# Control Frame Transport Proposal Version 3

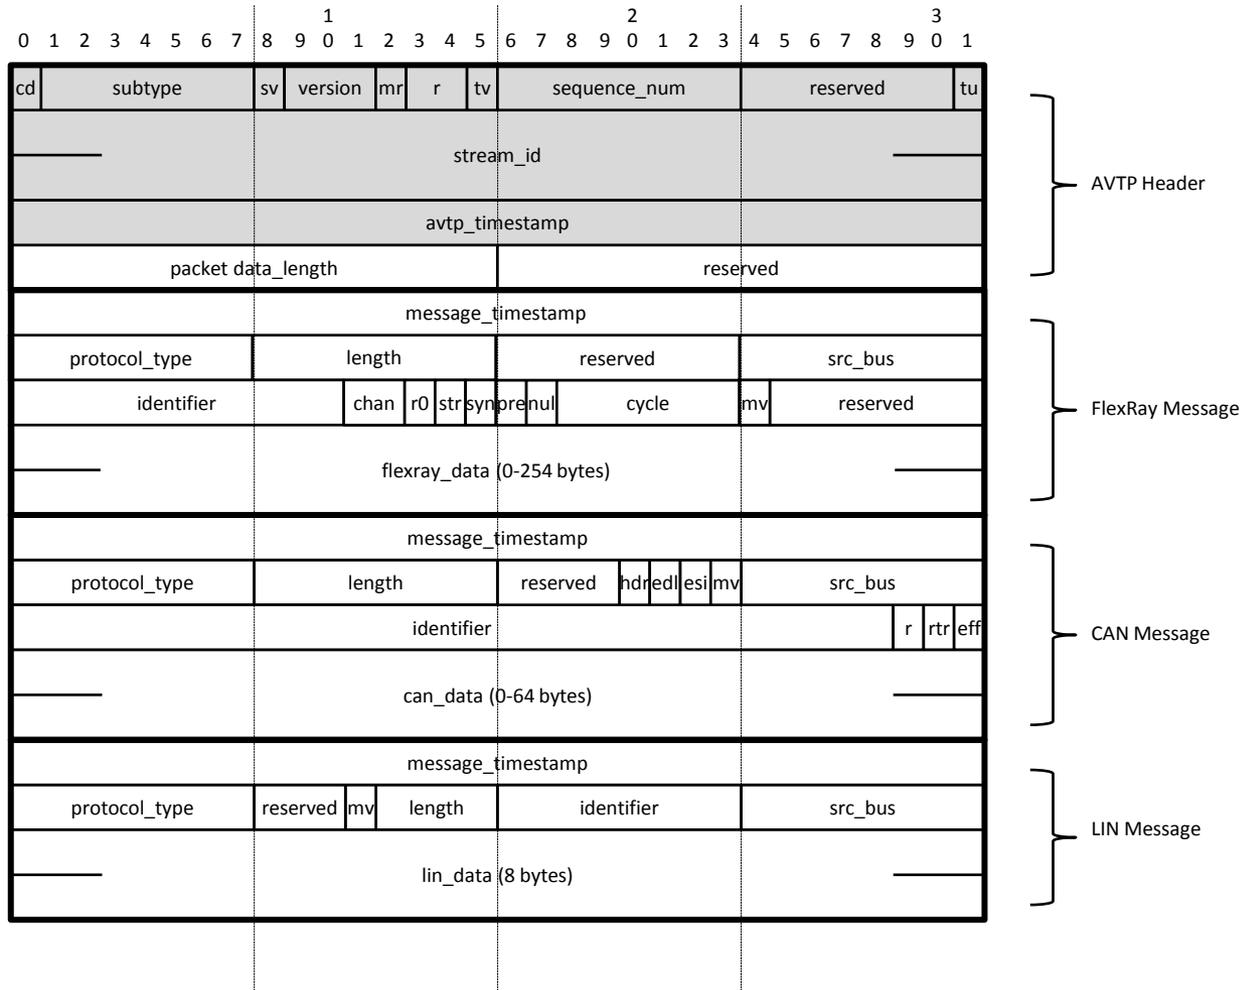
### – Field *num\_messages*

- This field opens a new store and forward context in the AVTP client layer (need to count automotive control frames and hand over to service layer).
- It cannot avoid the necessity to iterate over variable length control frame message TLVs.
- **Proposed Change:** Remove field *num\_messages* from specification. Alternative: define *num\_messages* as optional (*num\_messages* := 0 means field not set)

### – Field *dst\_bus* (Destination Bus ID)

- The field *dst\_bus* breaks automotive bus paradigms, which define automotive busses as native multicast media and defines receive side filter mechanisms. For instance, the field does not allow to multicast a control frame to multiple destination busses. It also contradicts to Ethernet's native multicast properties.
- **Proposed Change:** Remove field *dst\_bus* from specification. Note, that *src\_bus* is meaningful. Introduce an appropriate sender configuration mapping which allows to map frame IDs to transport descriptors. Introduce an appropriate receiver configuration which introduces subscription to a transport descriptor. A transport descriptor is basically the description of AVTP Ethernet stream. Does it make sense to communicate the sender mapping in a new field replacing *dst\_bus*?

# Proposed control frame messages – Option B

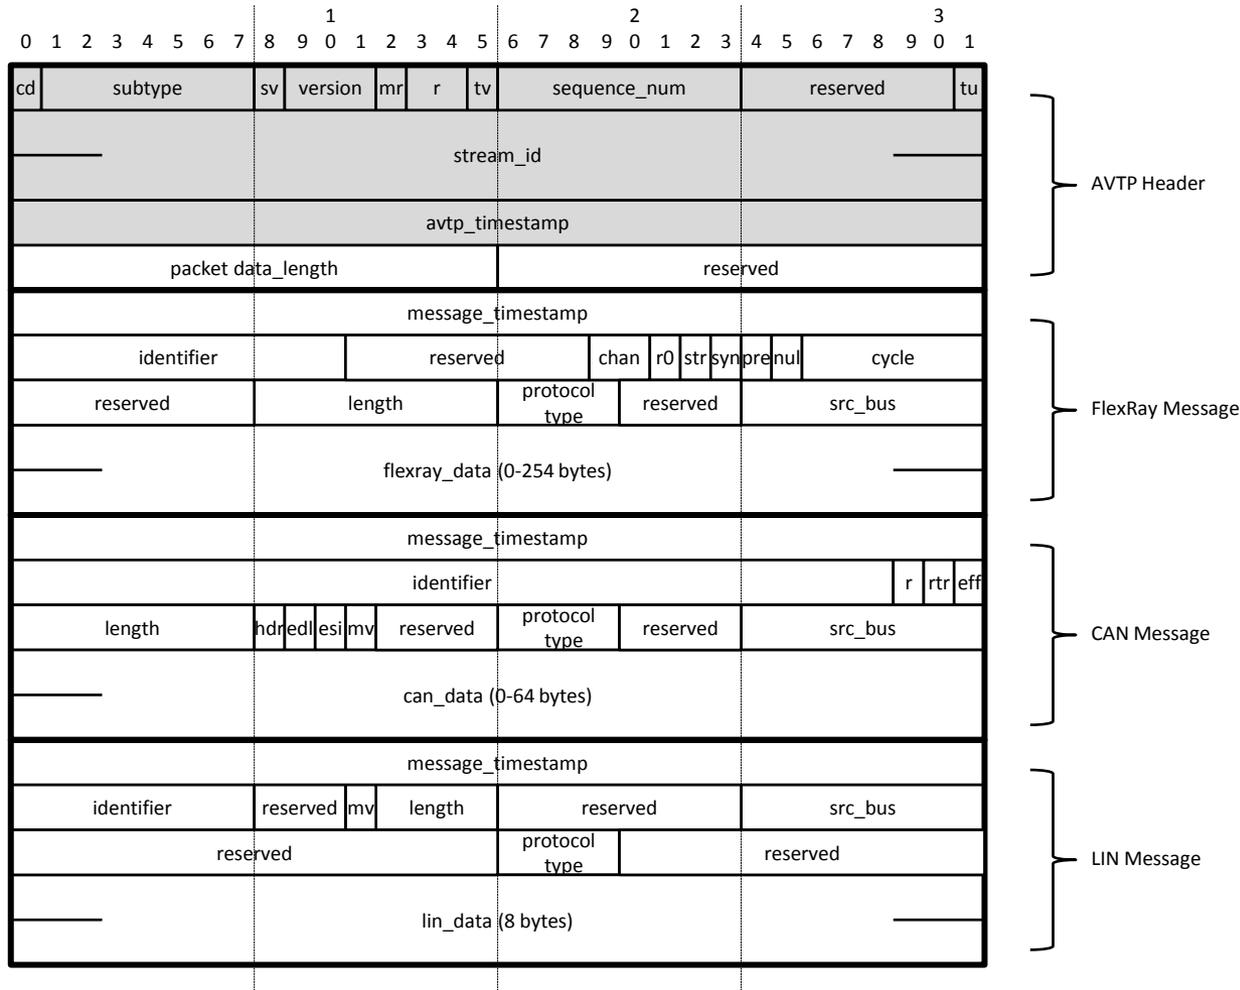
- Important Rule: *protocol\_type* must have the same offset for all messages
- Option B: minimum change of current frame format
